ADDENDUM No. 6 – February 11, 2019

S E-ADDENDUM No. 1 – May 1, 2018

PROJECT TITLE:
EARLY SITE BID PACKAGE #2
South High Community School
170 Apricot Street, Worcester, MA 01603

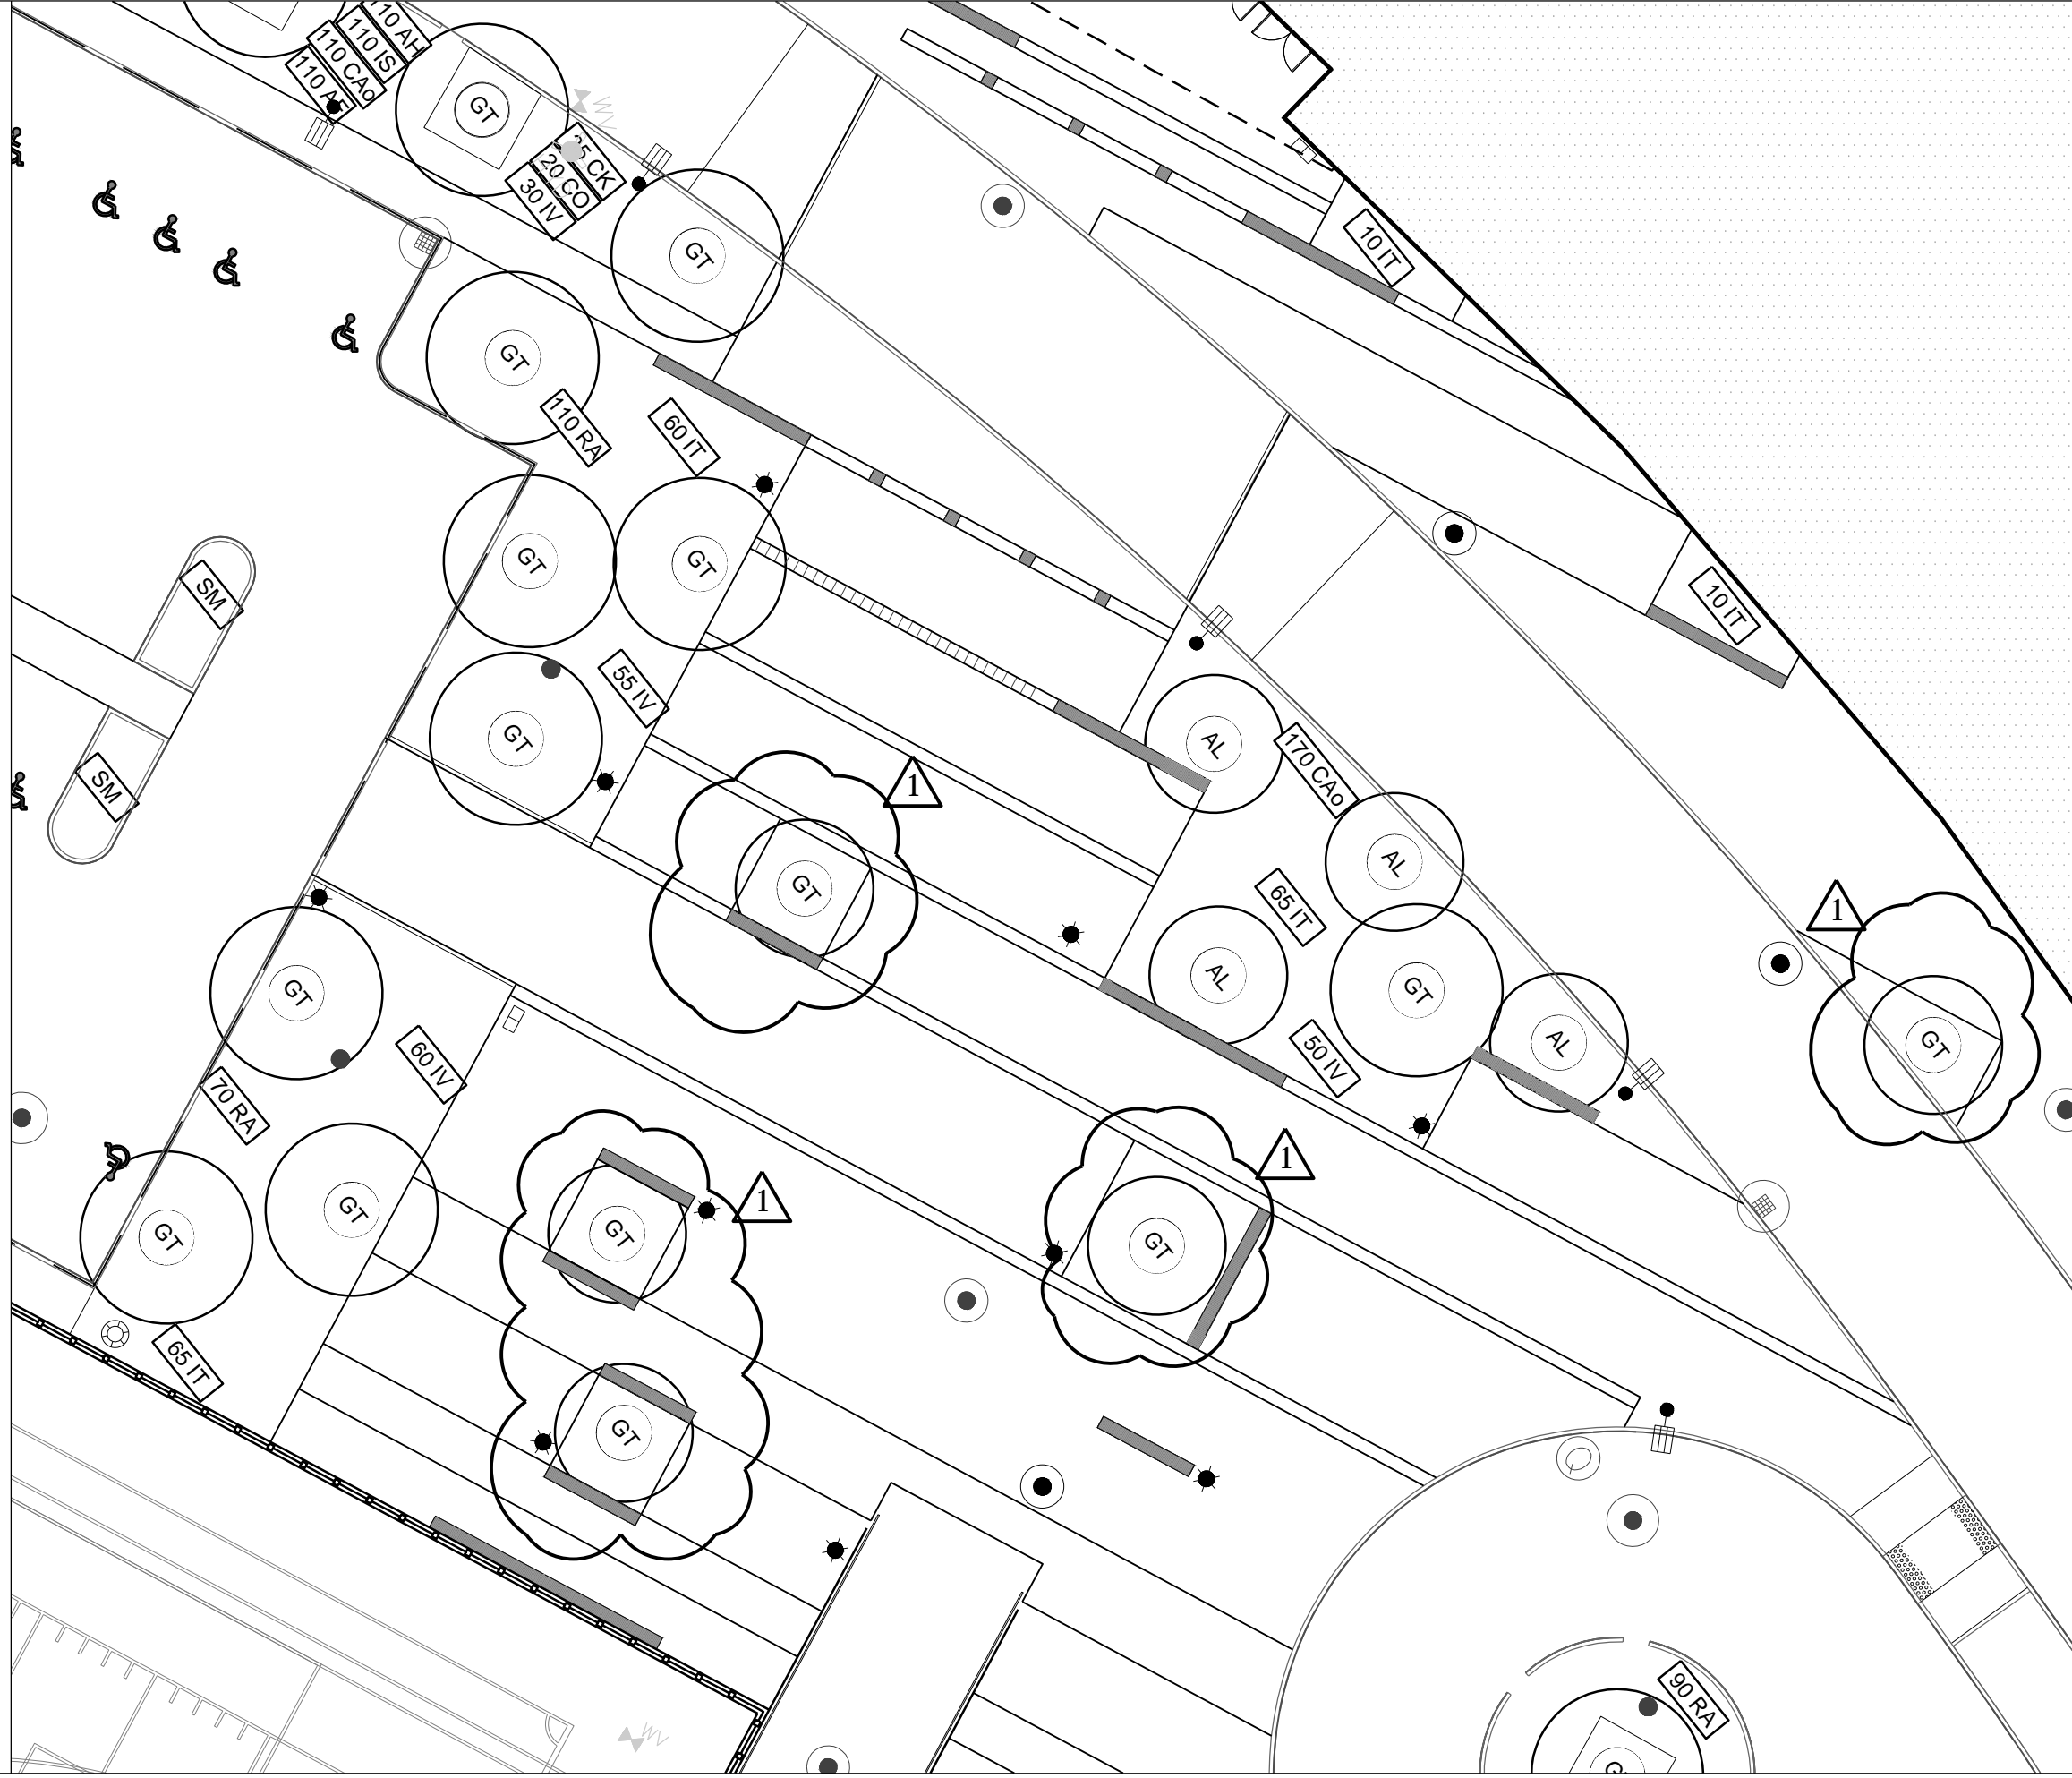
1 Five (5) trees changed from AL to GT

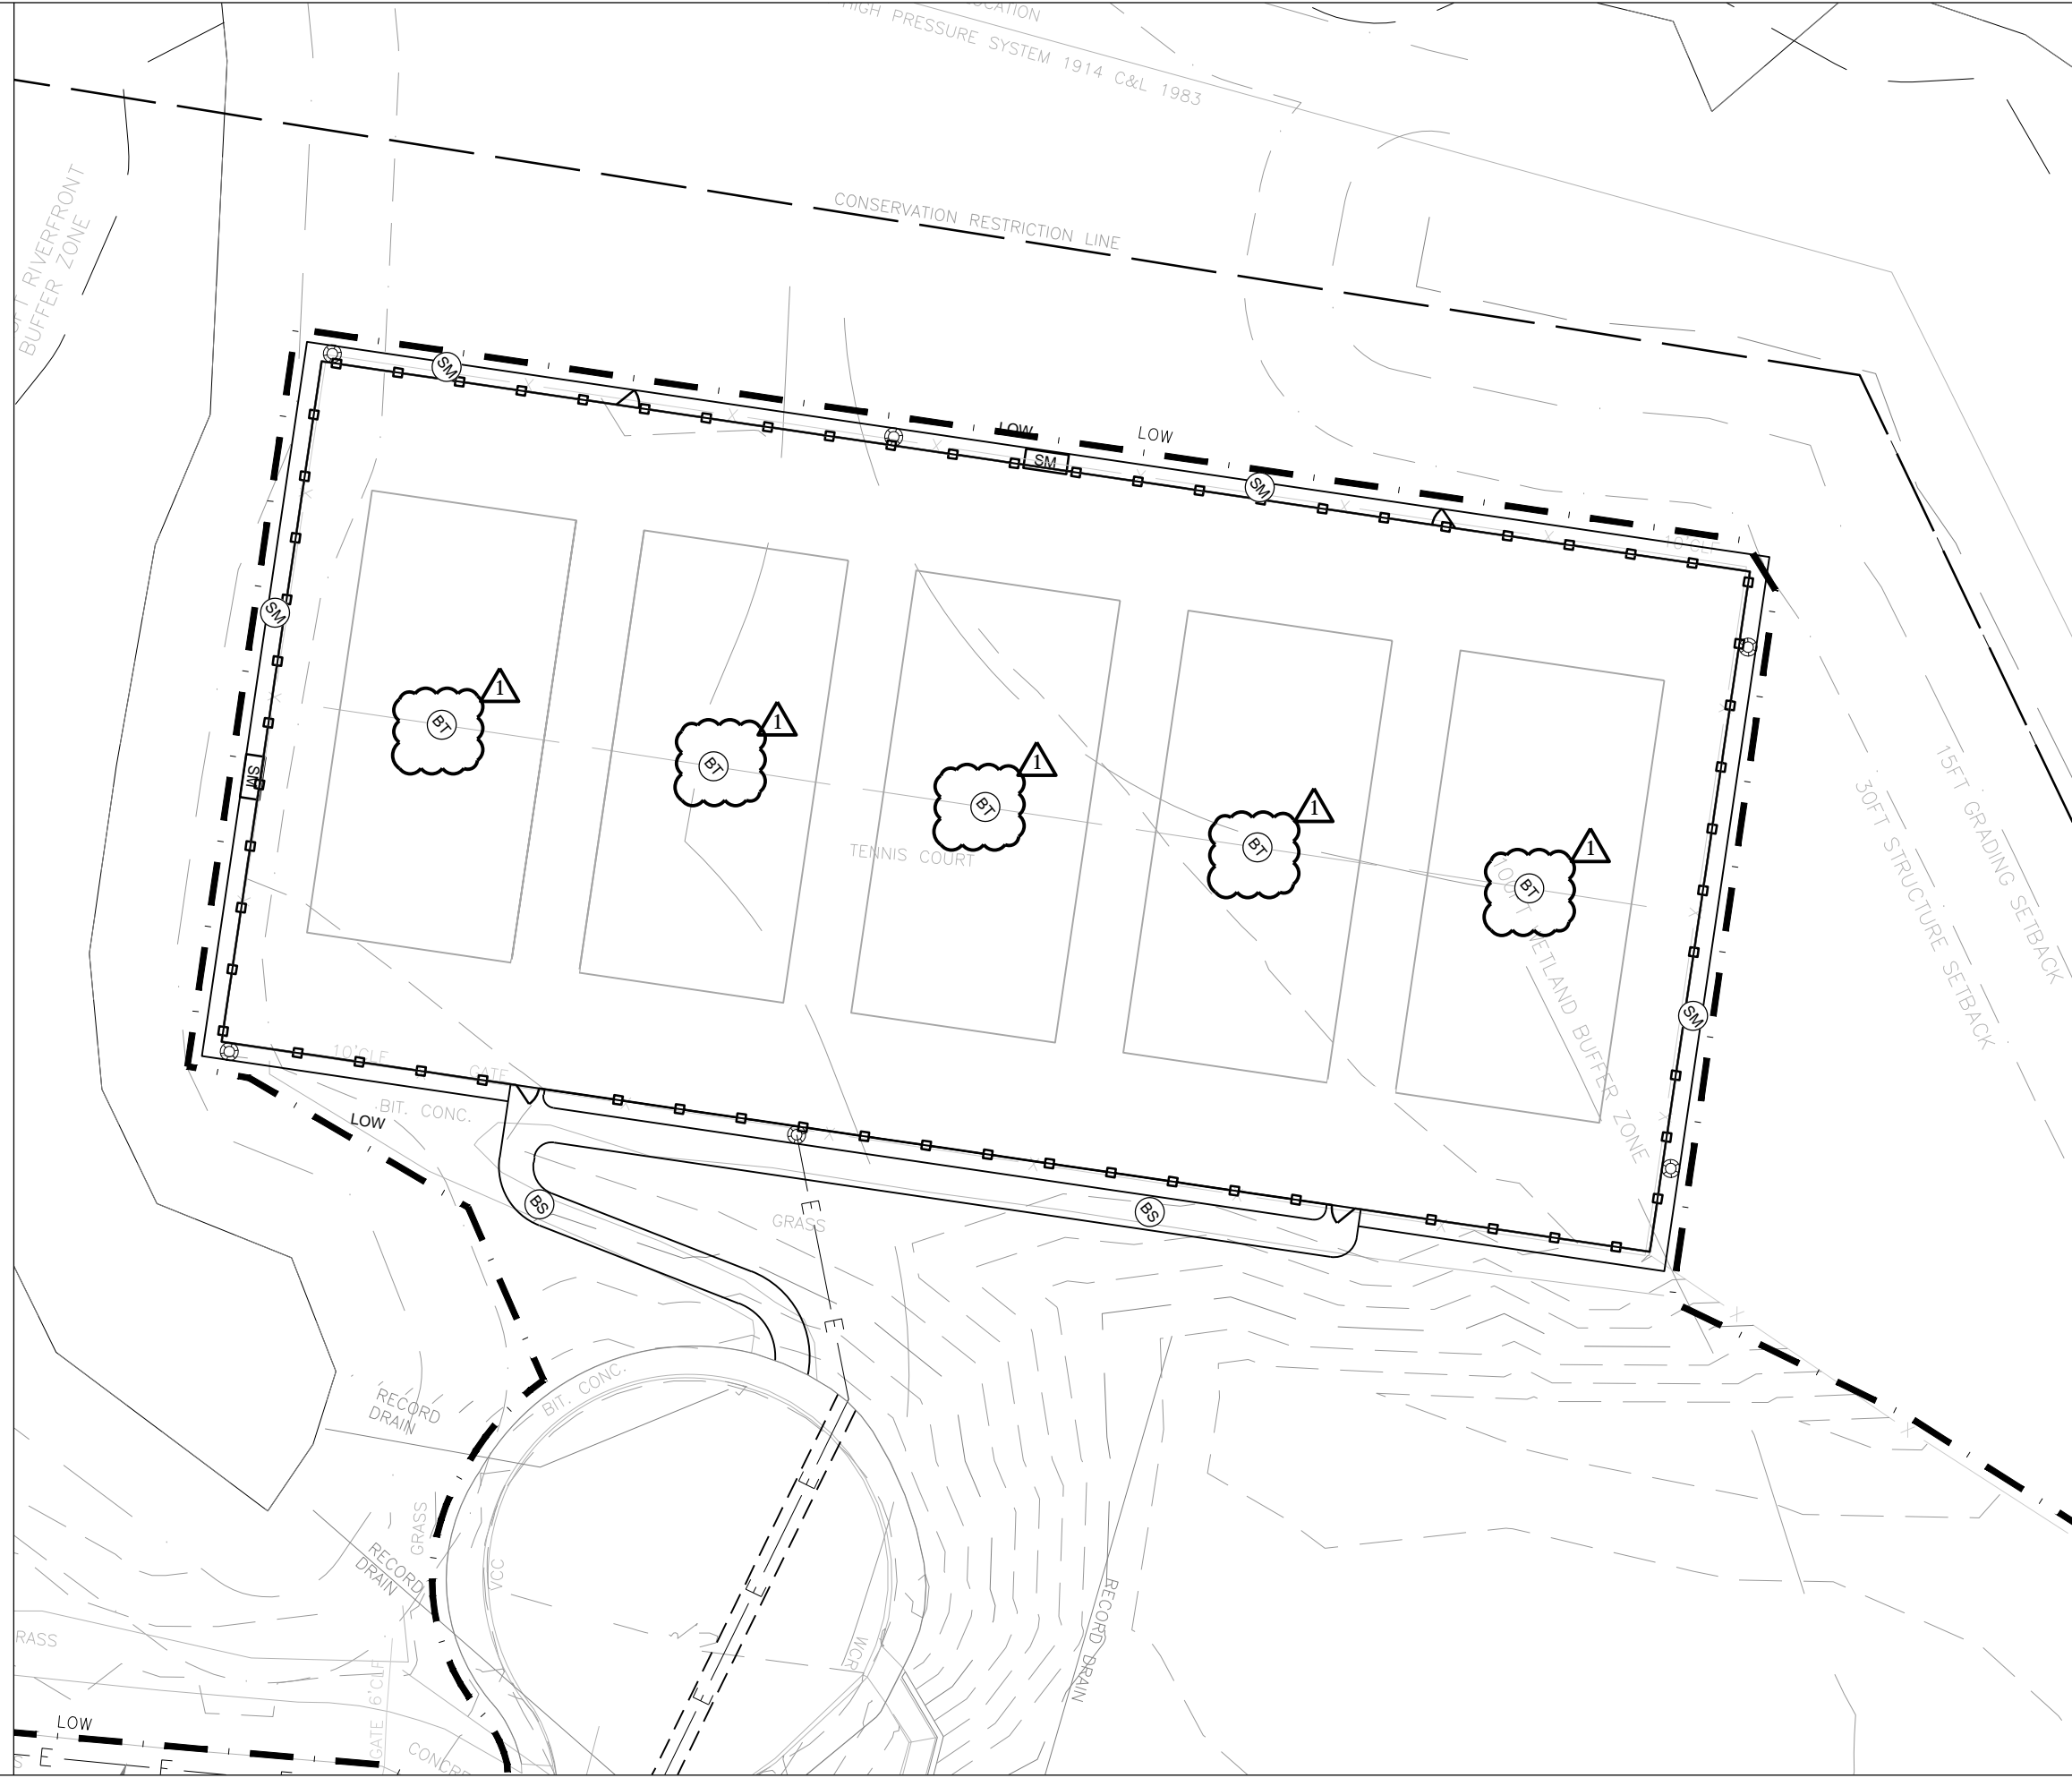
Clarification that five (5) sets of tennis equipment should be provided as specified.

SHEET REF. NO.	C8.0
DRAWING NUMBER:	ADD-3 C-003
DRAWING NAME:	Site Utility Plan Sketch
DATE:	09/17/18
SCALE:	1" = 20'

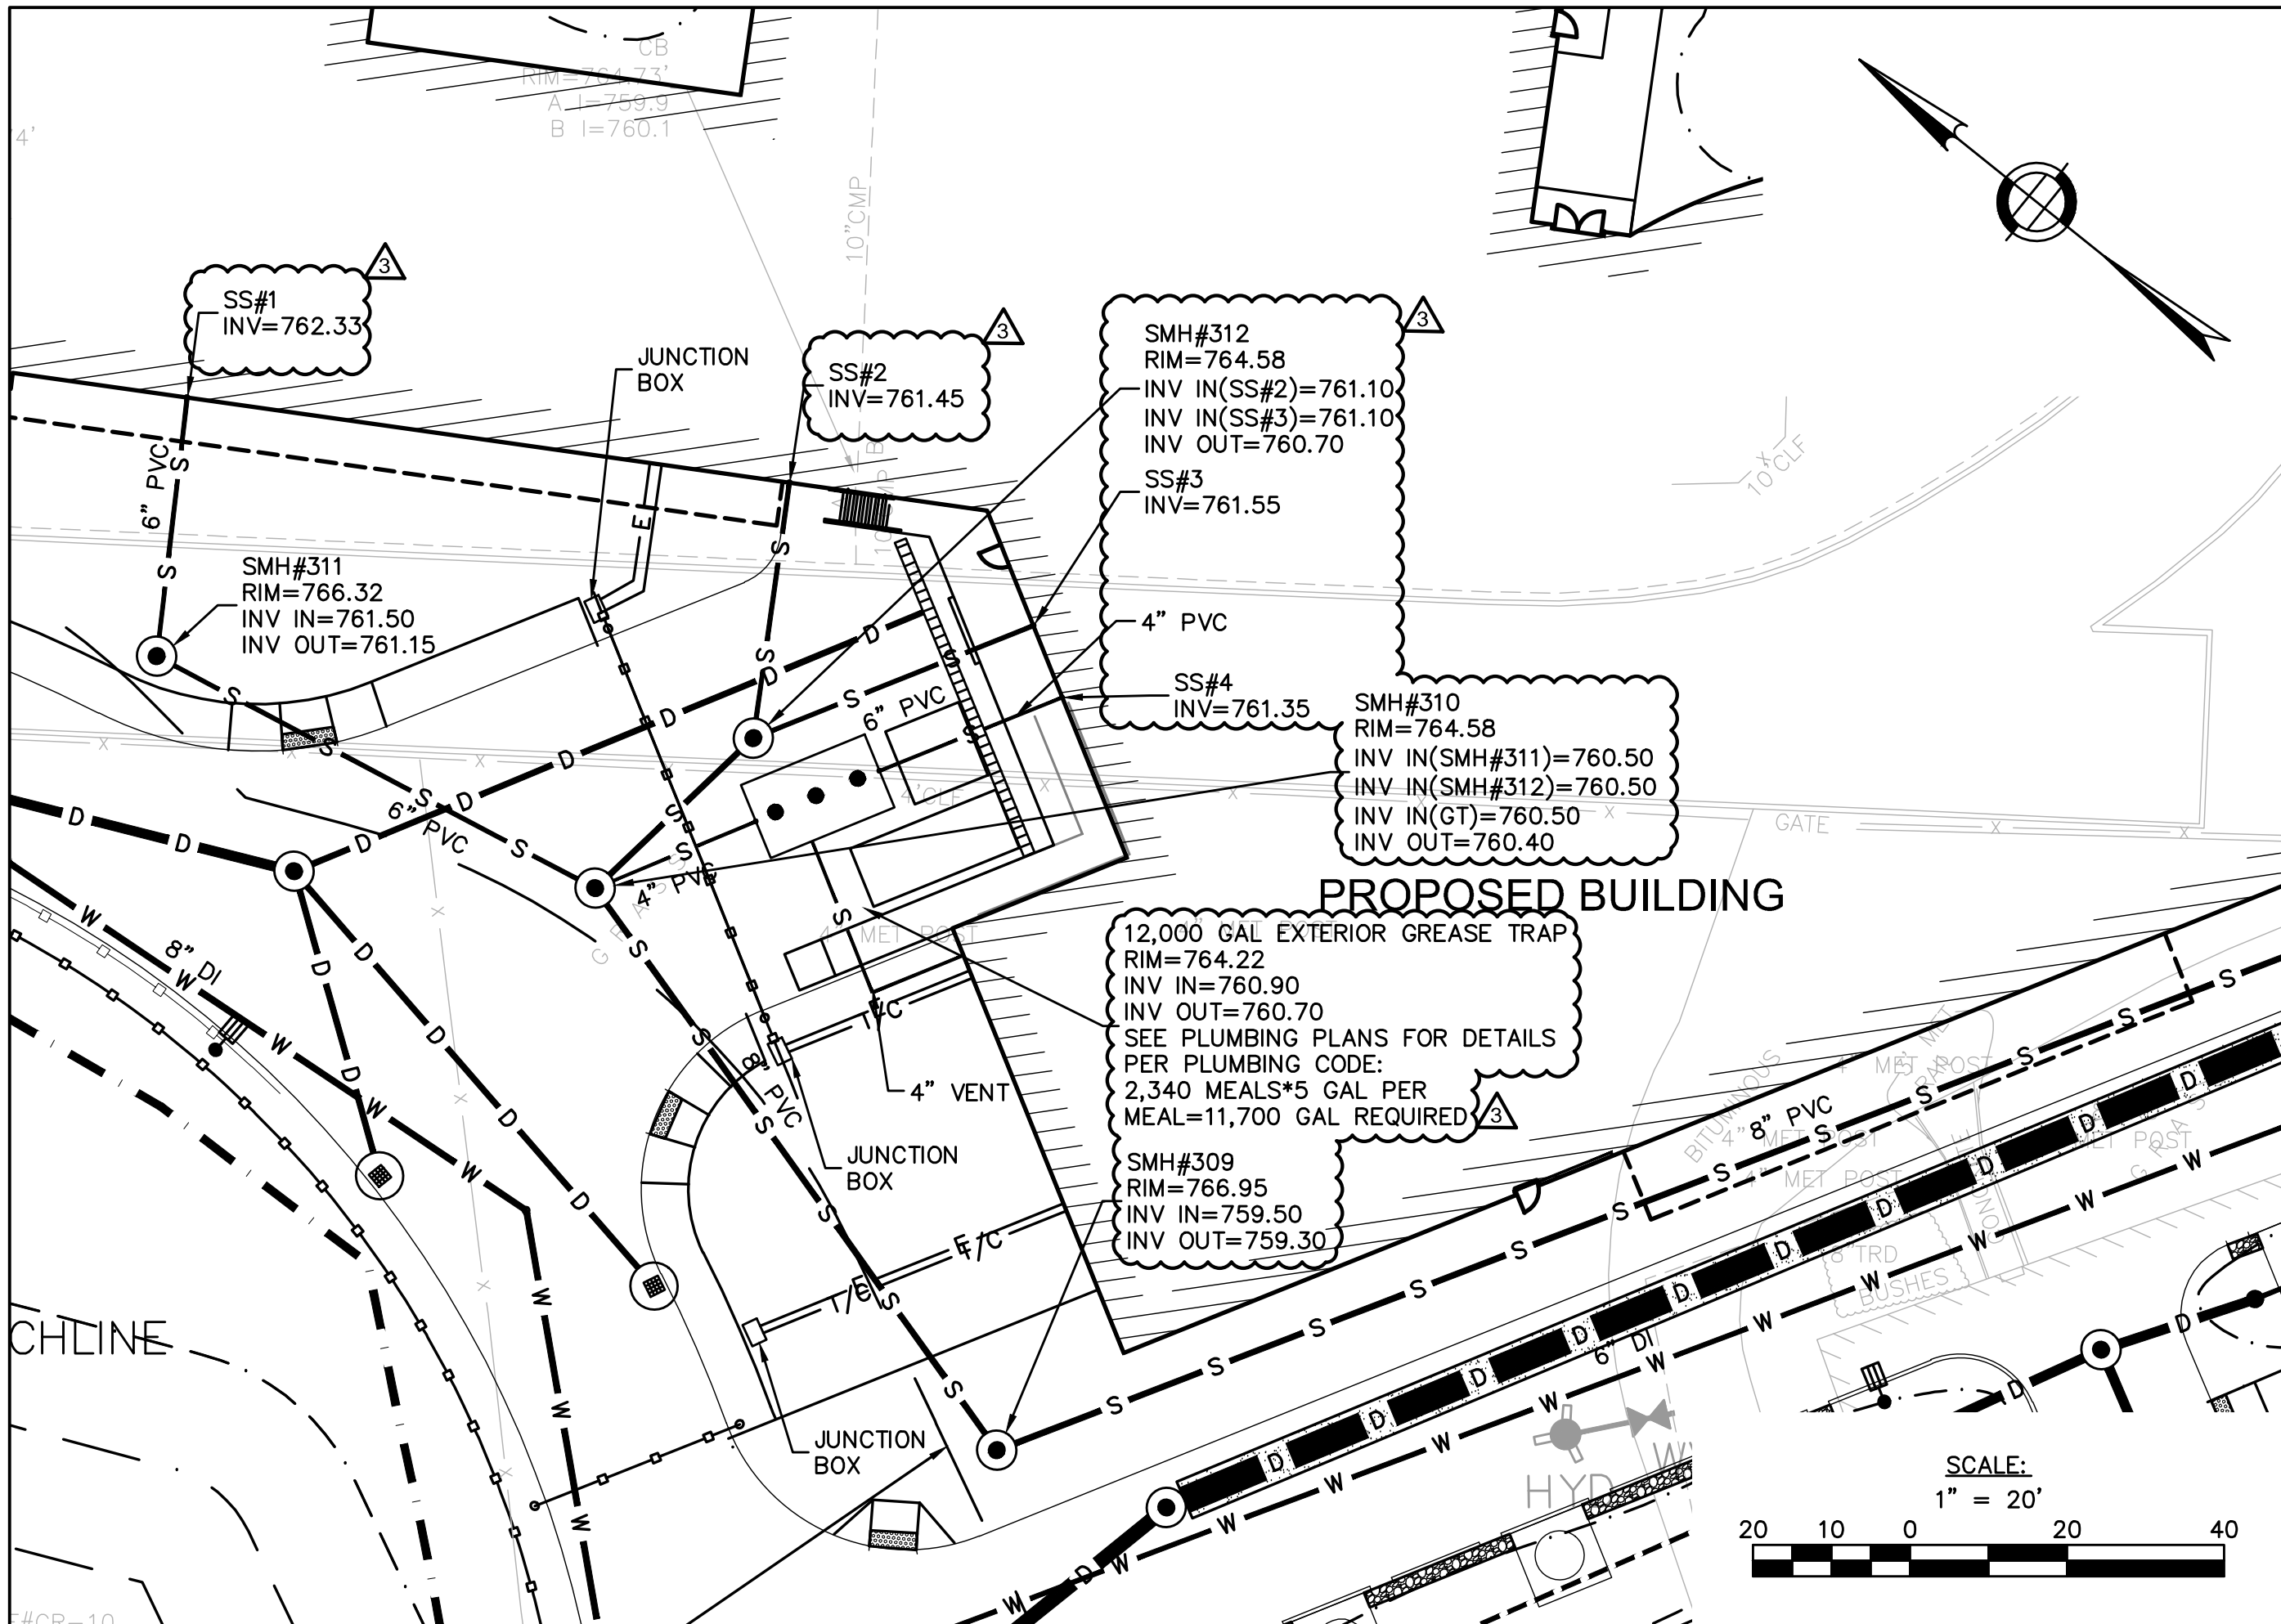
- A. Delete sketch ADD-2/C-003; replace with ADD-3/C-003
- B. Delete sketch ADD-2/C-004; replace with ADD-3/C-004
- C. Delete sketch ADD-2/C-017; replace with ADD-3/C-017
- D. Delete sketch ADD-2/C-018; replace with ADD-3/C-018
